**ADDENDUM  
NO. 01**

**January 27, 2026**

**Kalamazoo Public Schools Northglade Montessori Magnet  
1914 Cobb Ave  
Kalamazoo, MI 49007**

## ARCHITECT'S SUPPLEMENTAL INSTRUCTIONS ASI #001

## FLOOR PROTECTION PLAN

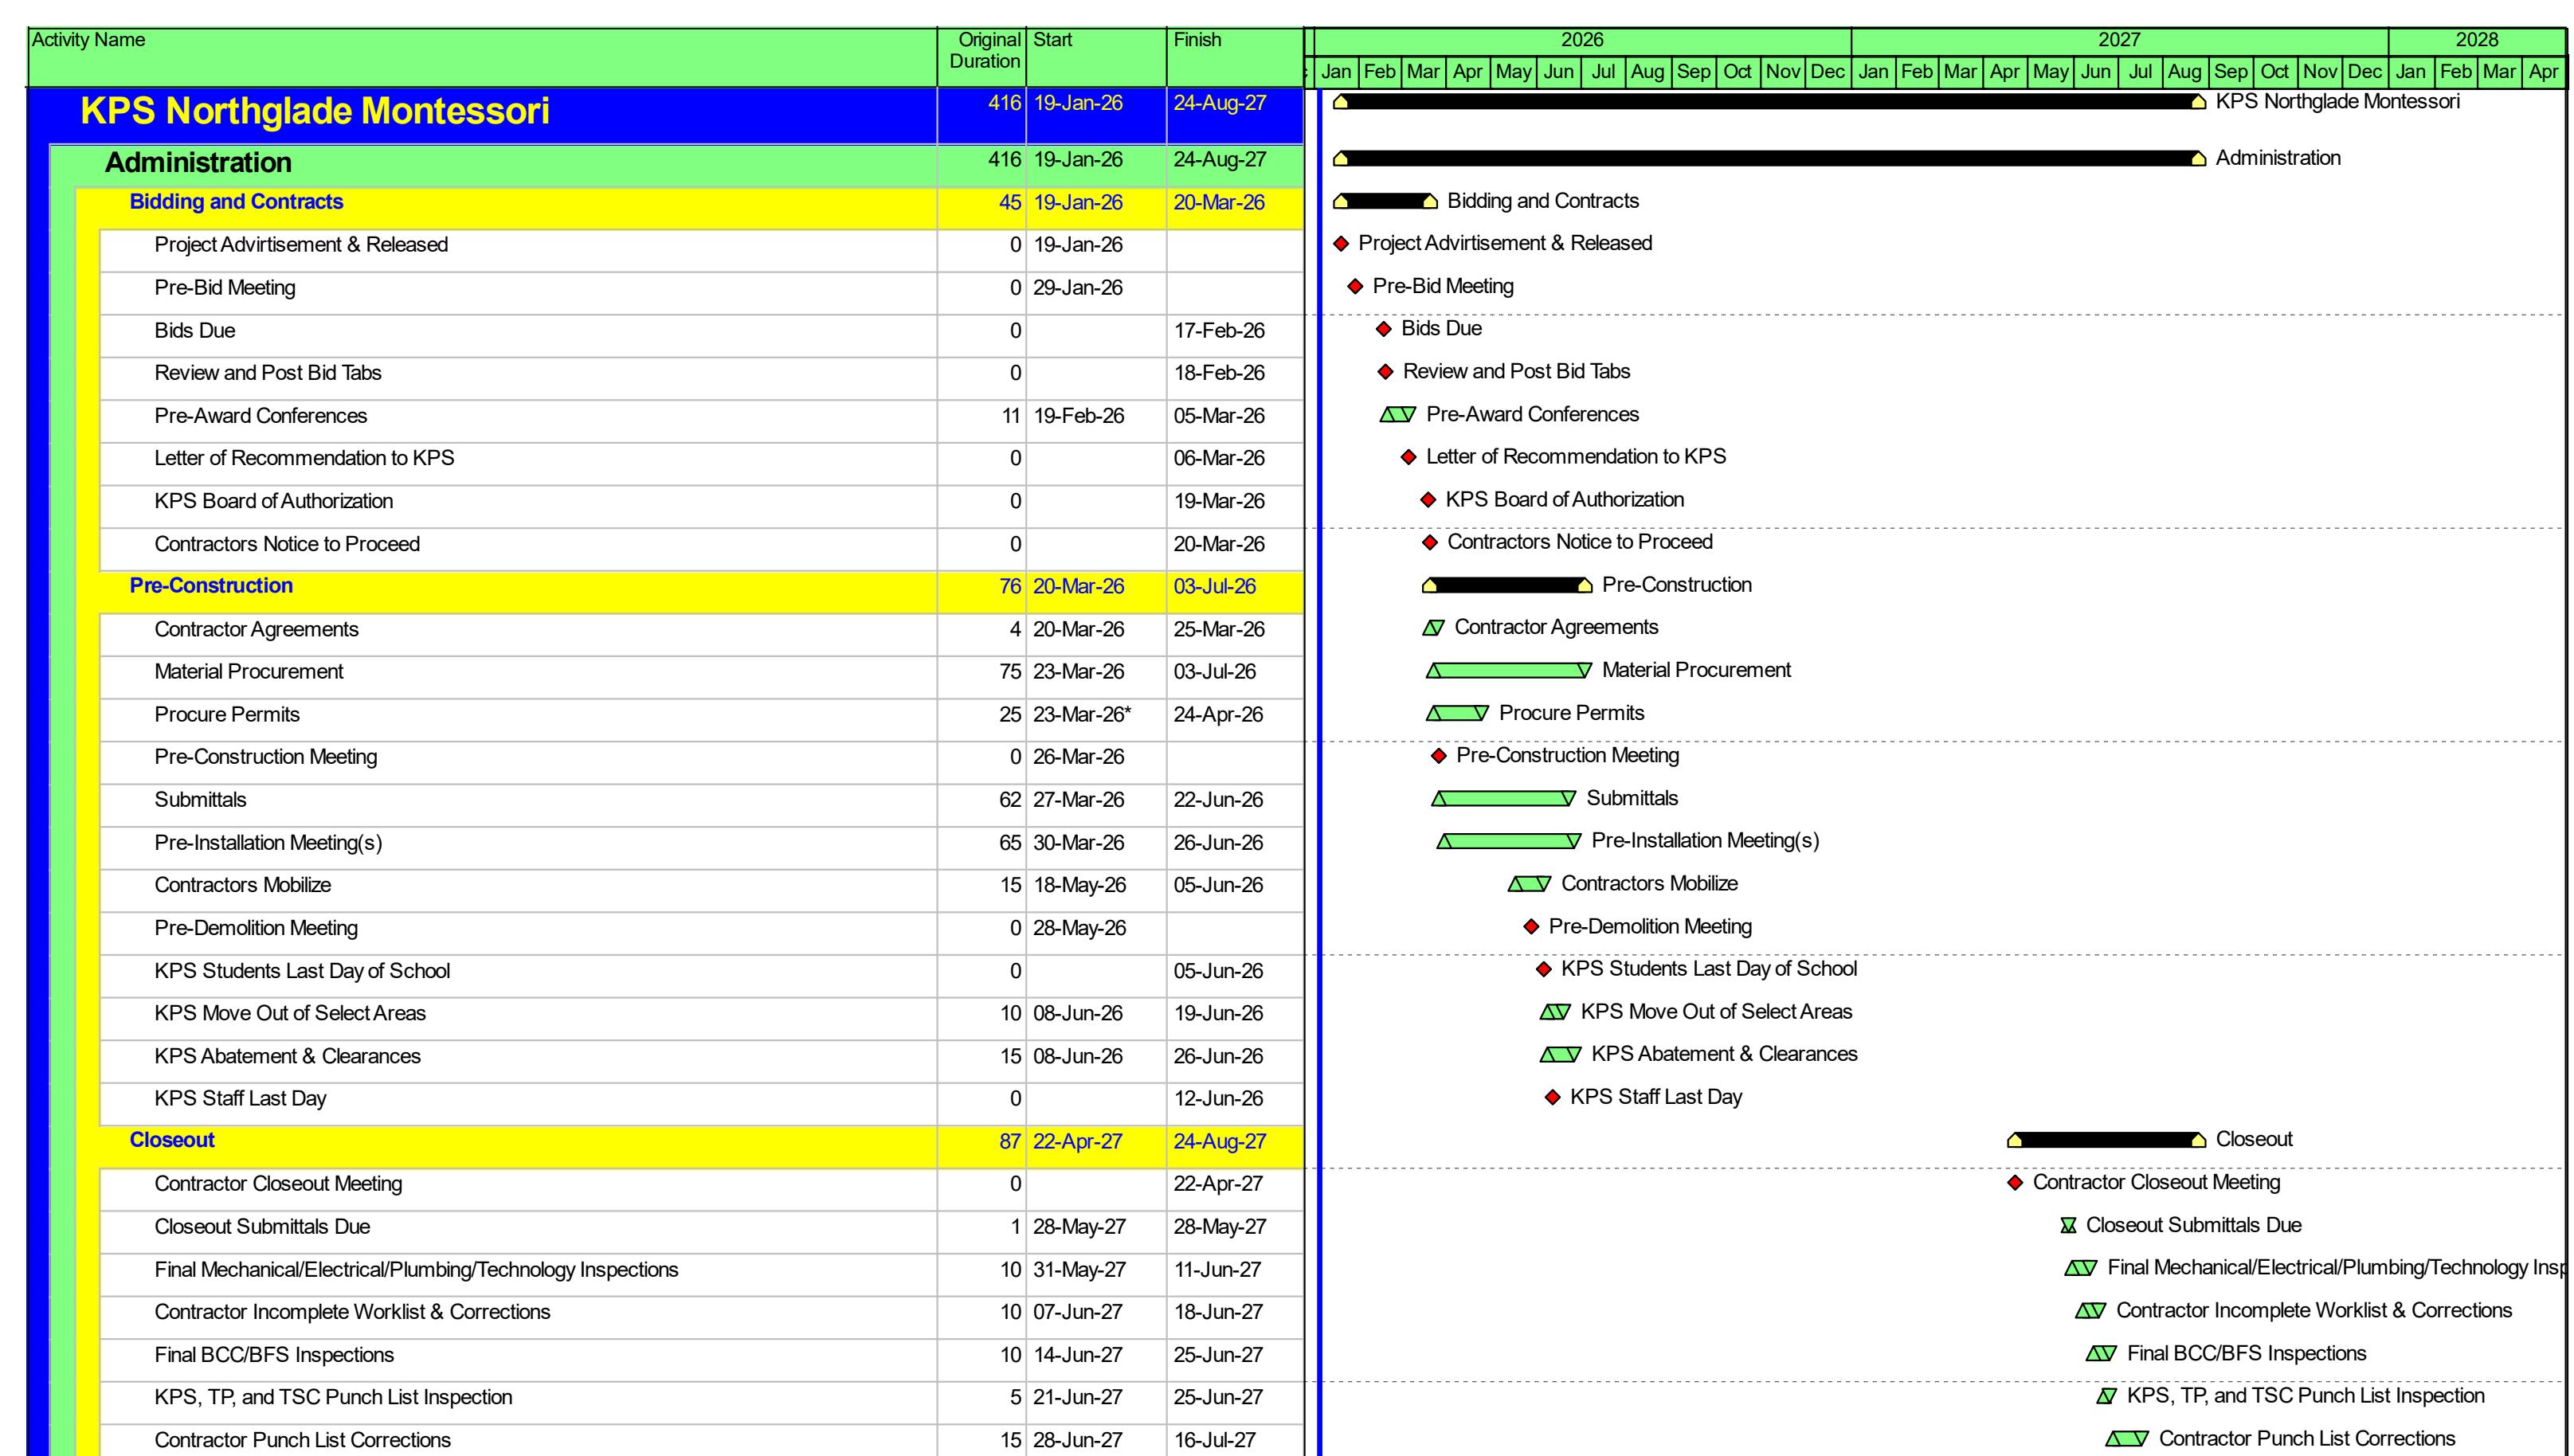
5. **Clarification No. 05: Bid Category No. 01 – General Trades** shall provide housekeeping pads in B12A.
6. **Clarification No. 06: Bid Category No. 01 – General Trades** to install, maintain and remove flooring protection for locations outlined in the attached "Flooring Protection Plan" using plastic sheeting under masonite or equivalent.

G 101 – First Floor Code Compliance Plan

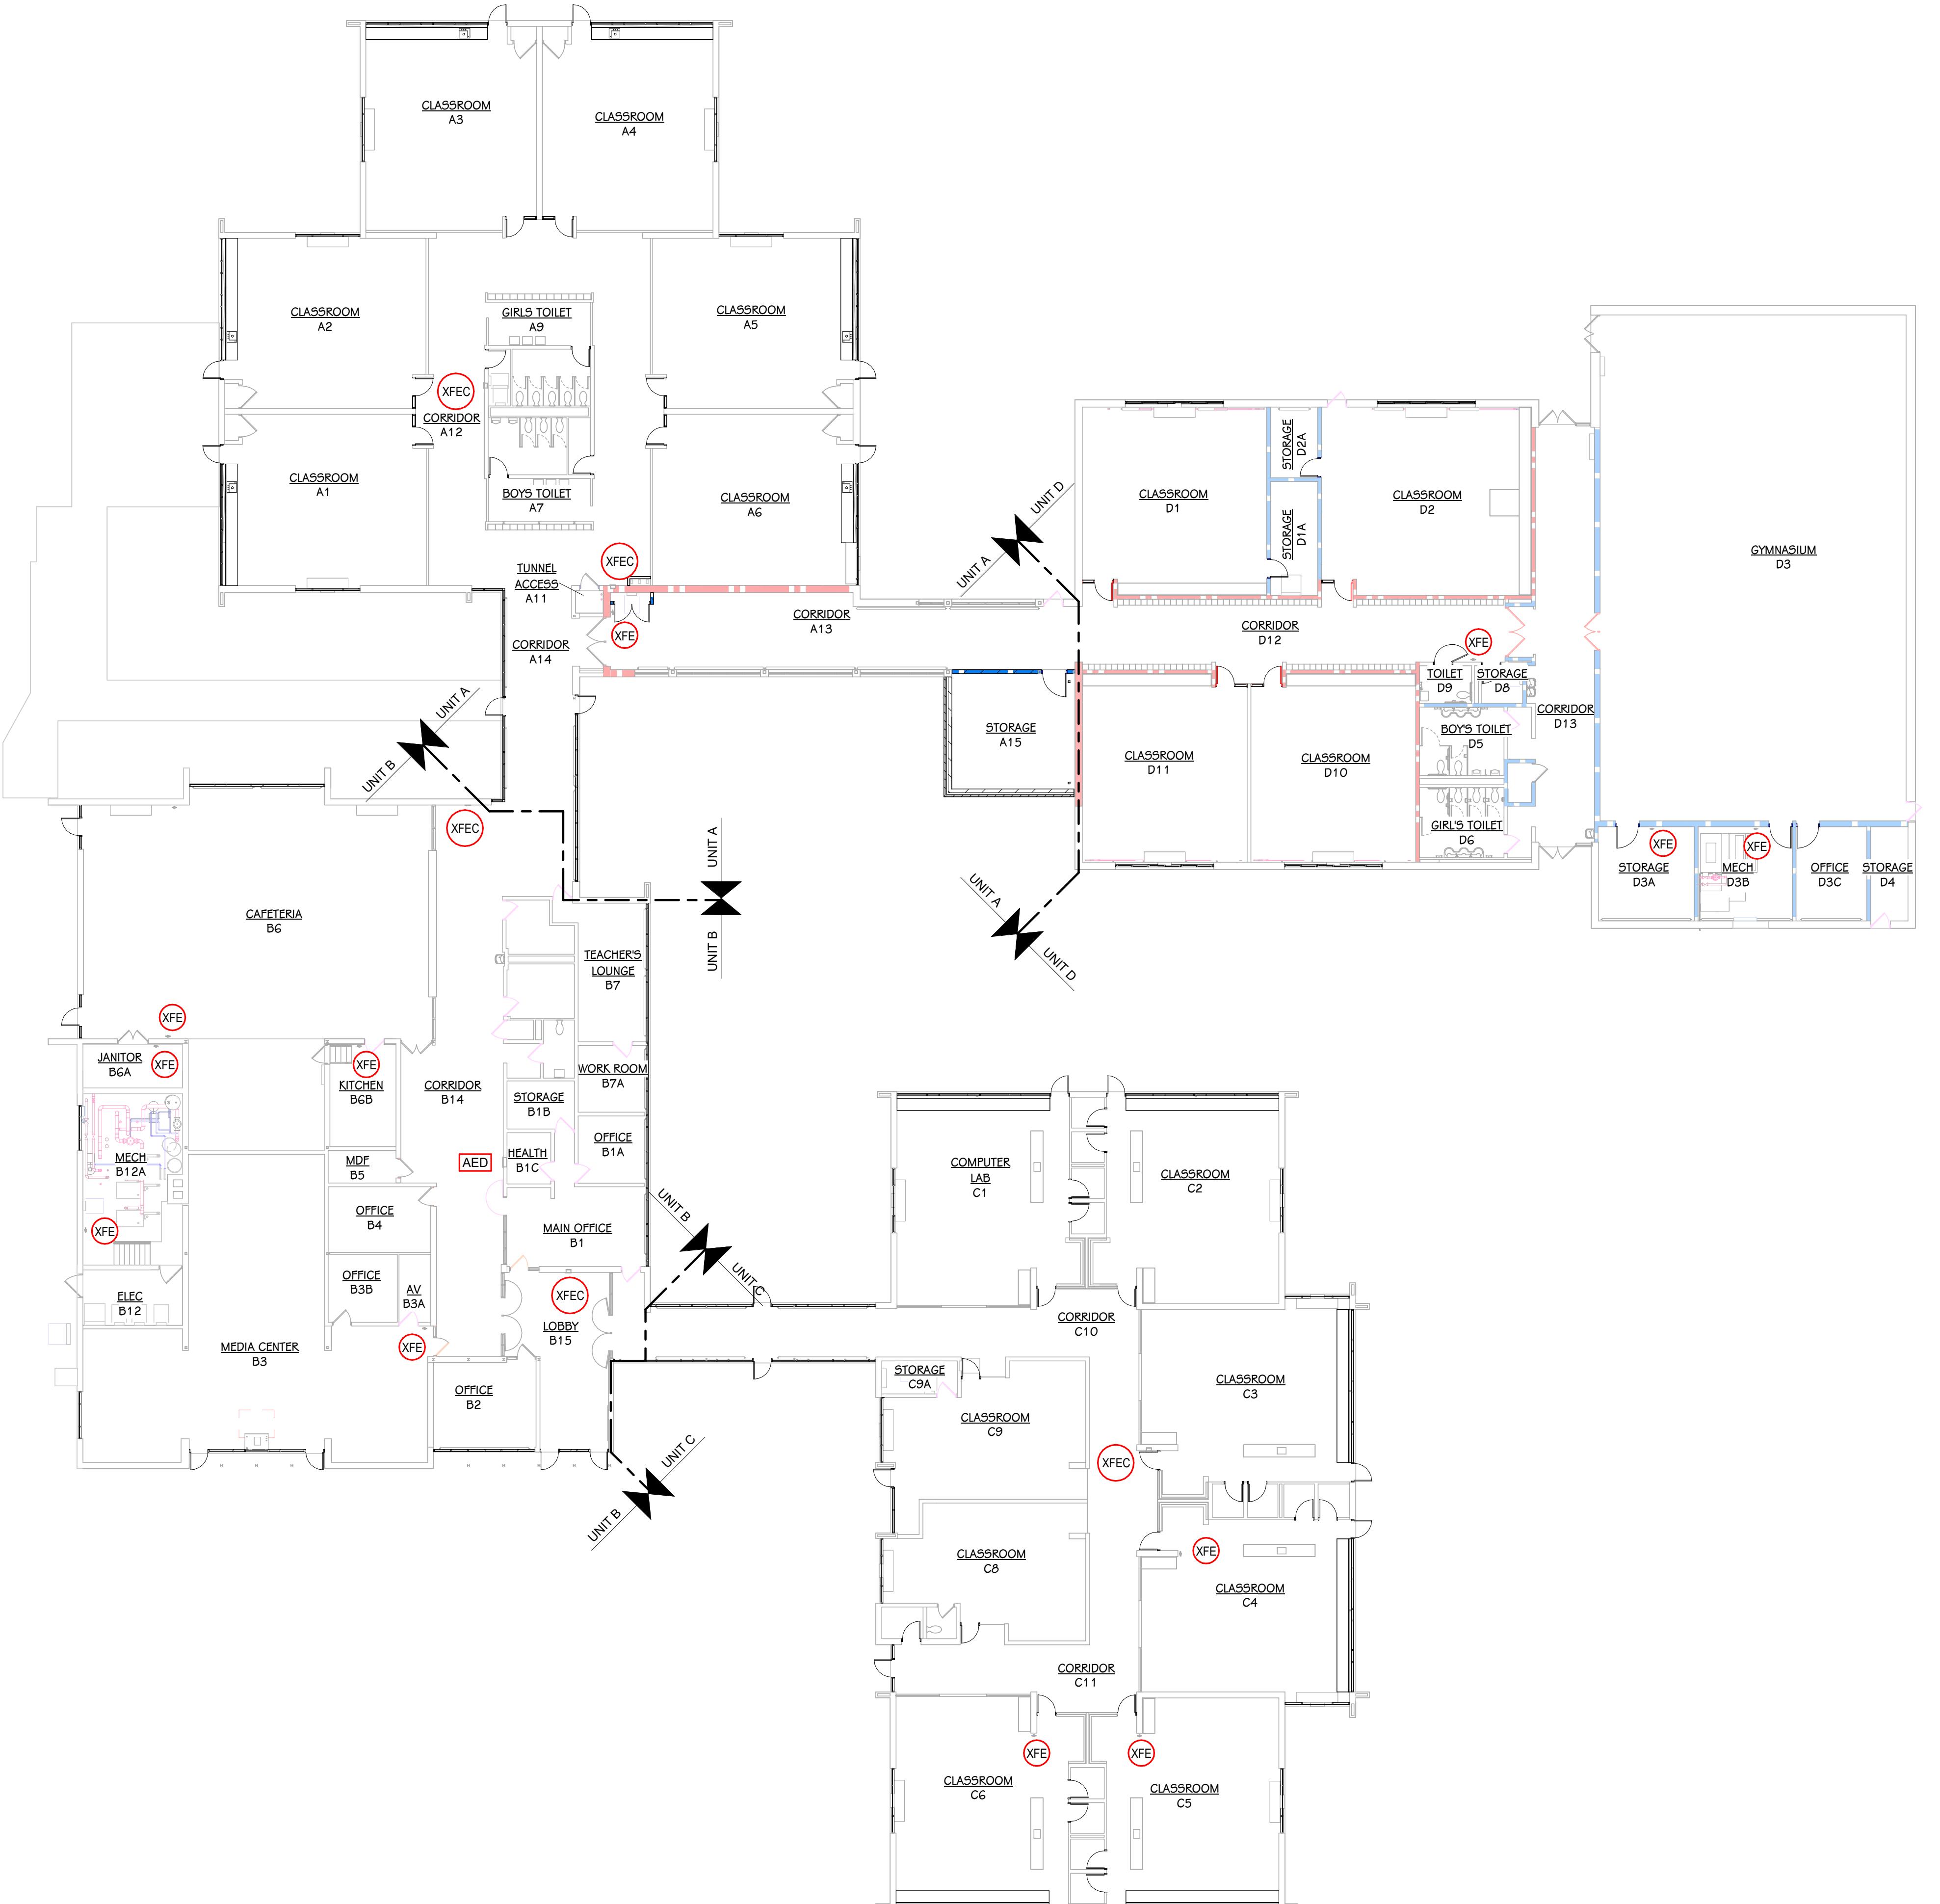
Reference code year for International Fuel Gas Code updated to 2021.
